Tropico Middle School Landscape, Drainage and Parking Lot Upgrade Project
SOUTHERN KERN UNIFIED SCHOOL DISTRICT
F&M Project No. 2940.0400
Bid Clarification No. 1; Page 1 of 11

BID CLARIFICATION NO. 1

January 6, 2025

C3.04

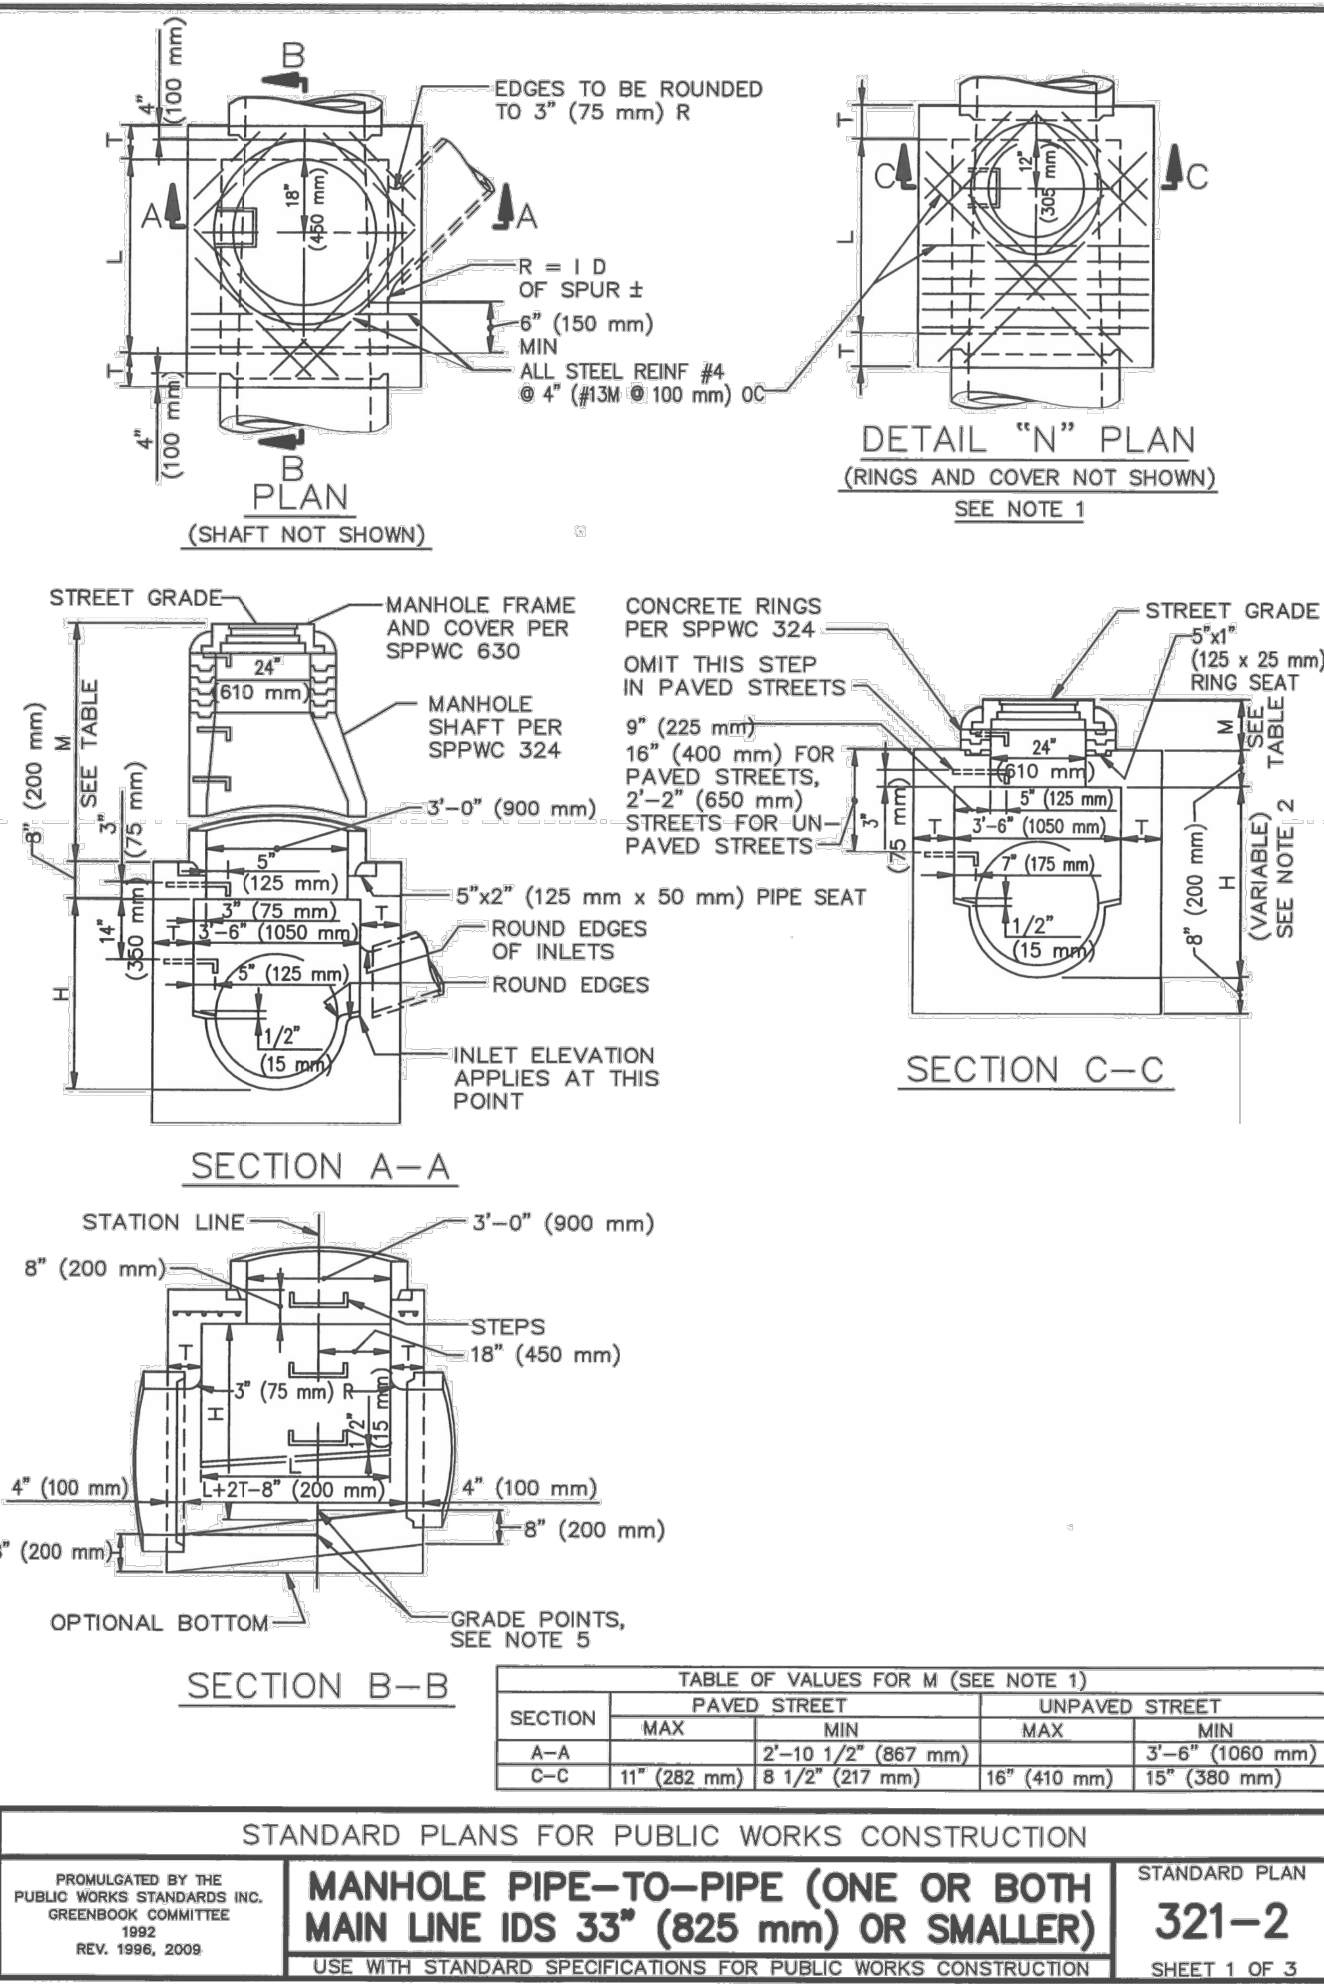
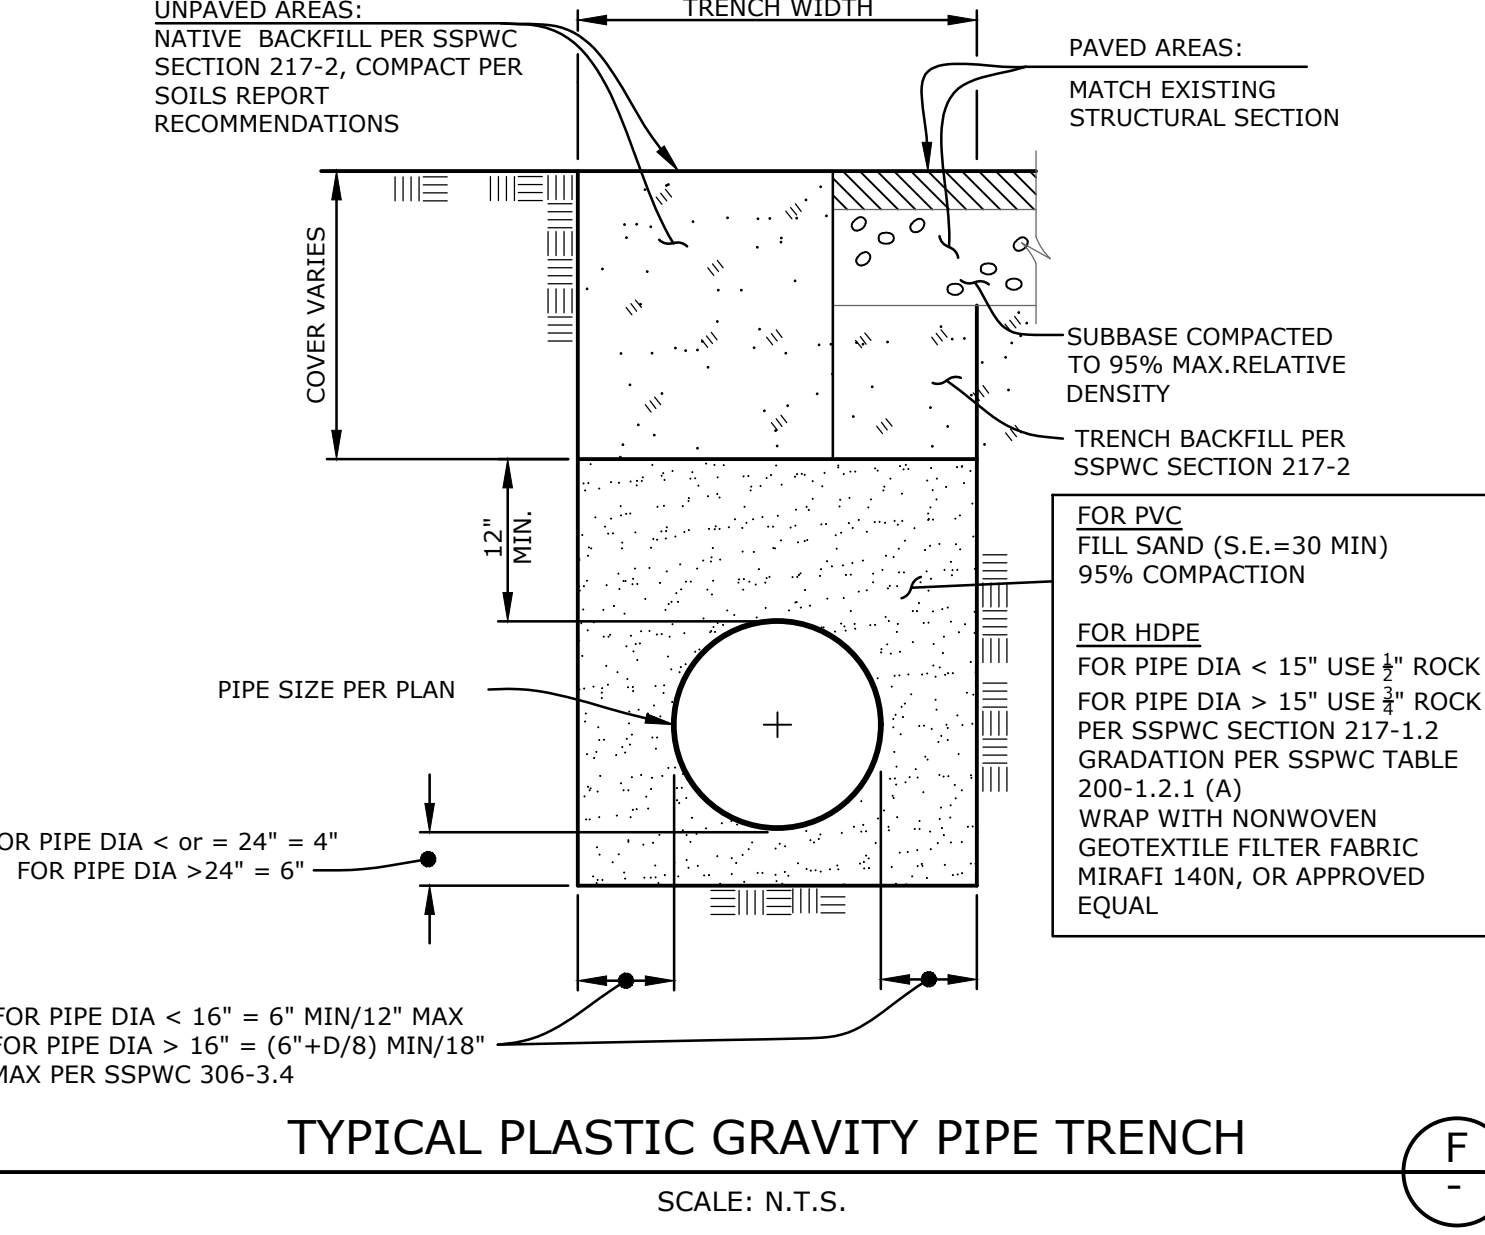
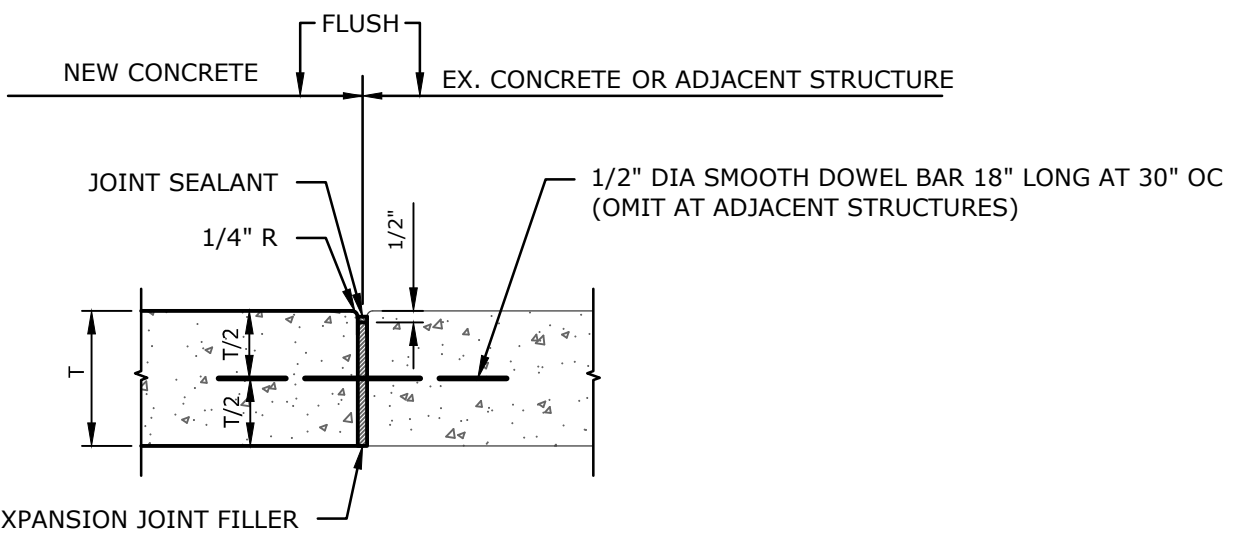
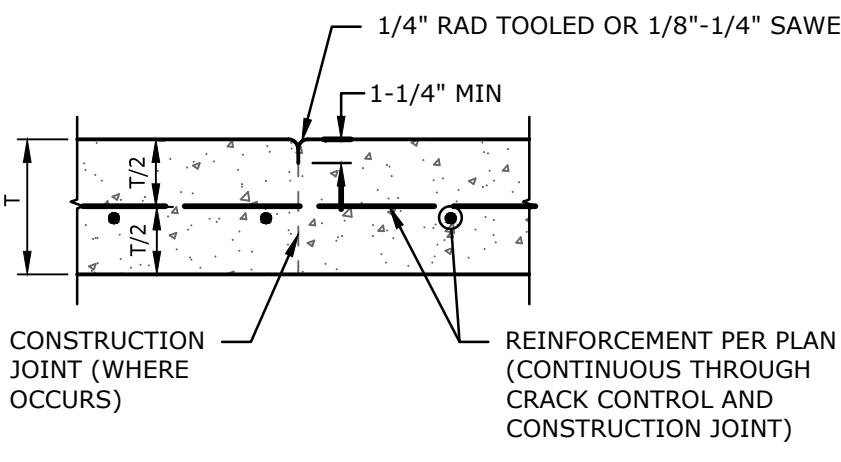
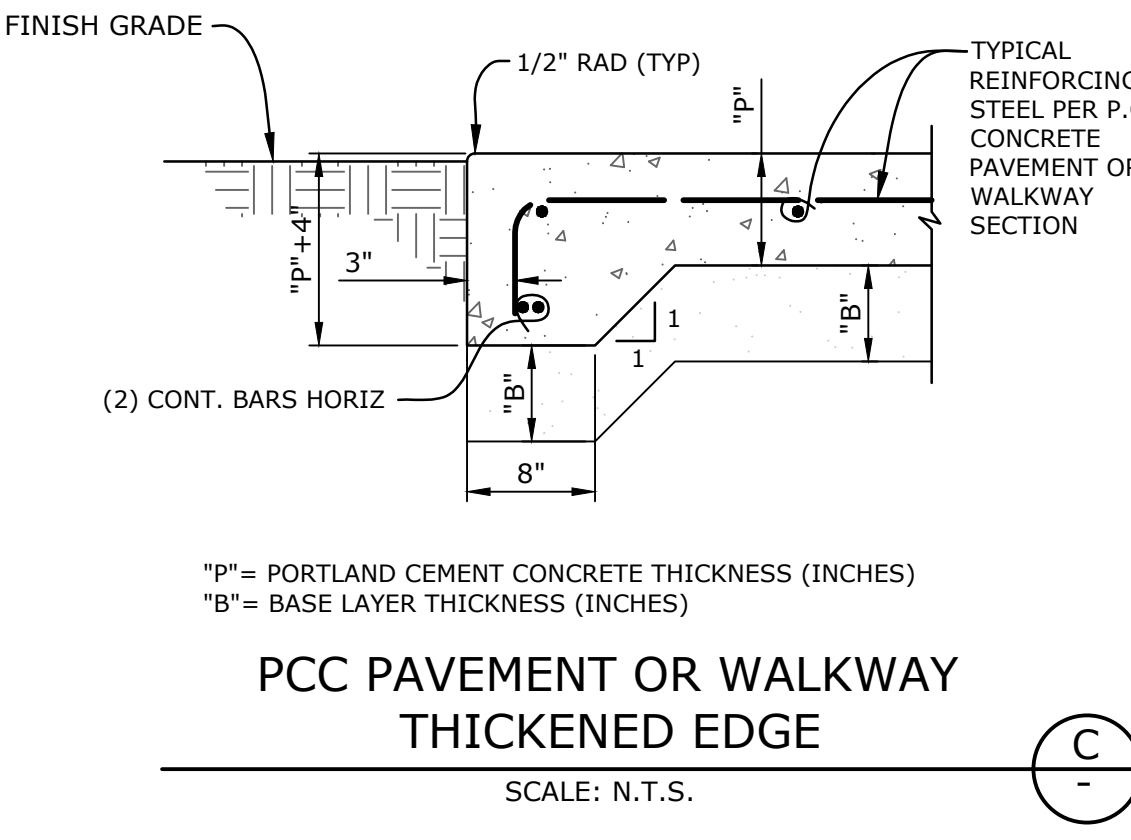
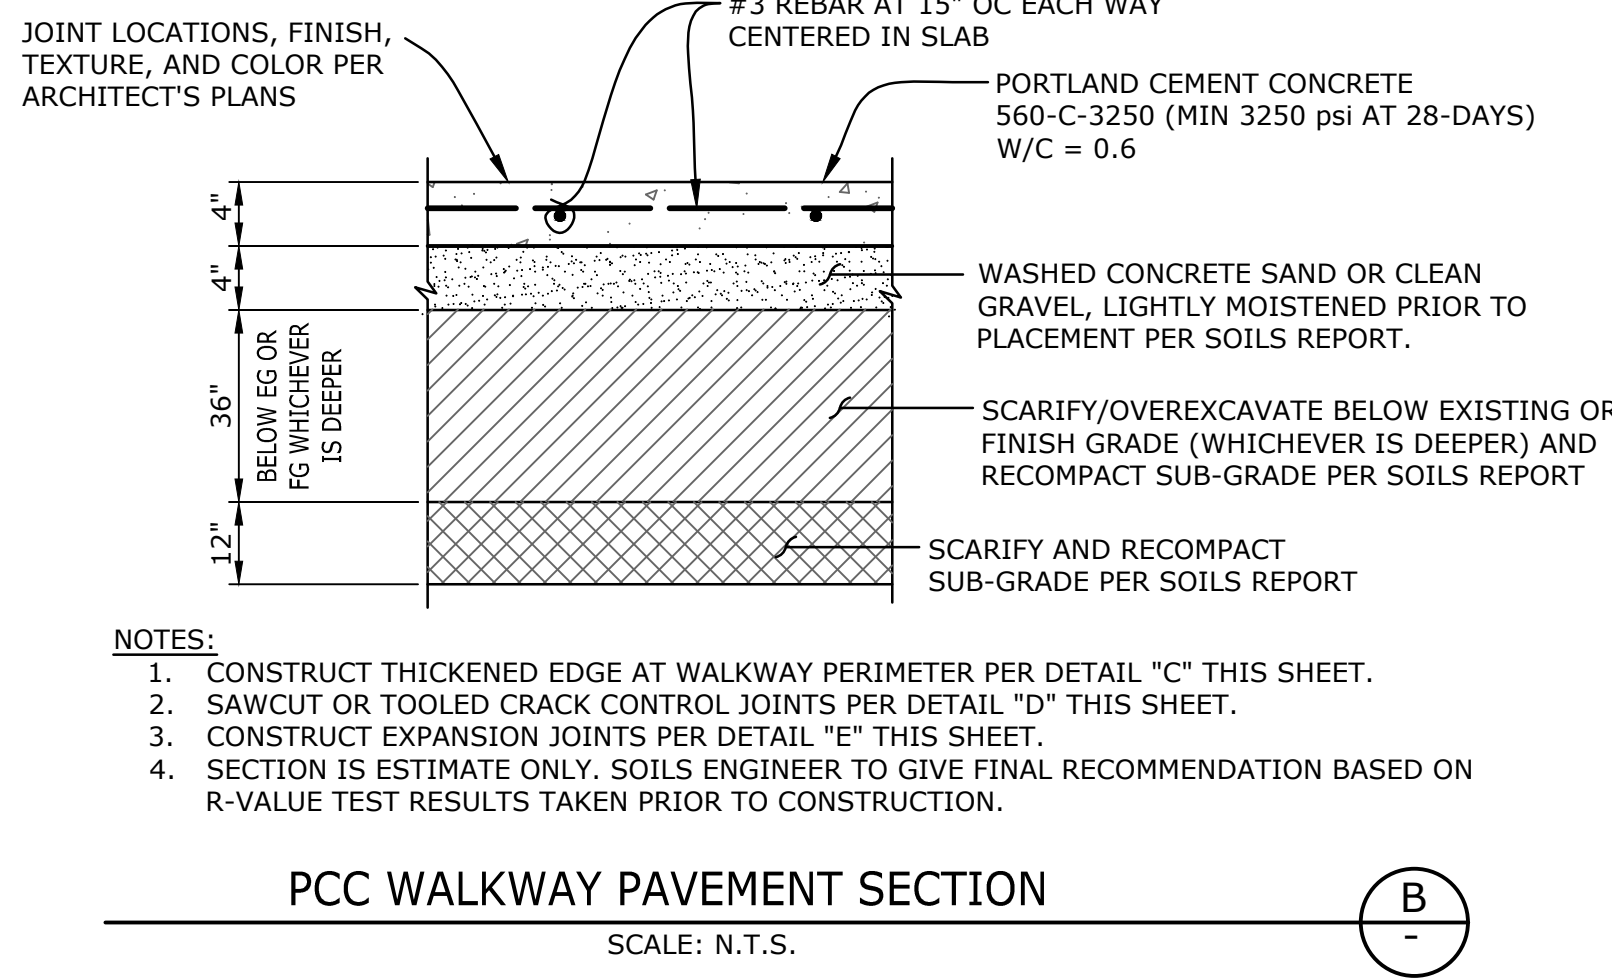
BID ALTERNATE #1
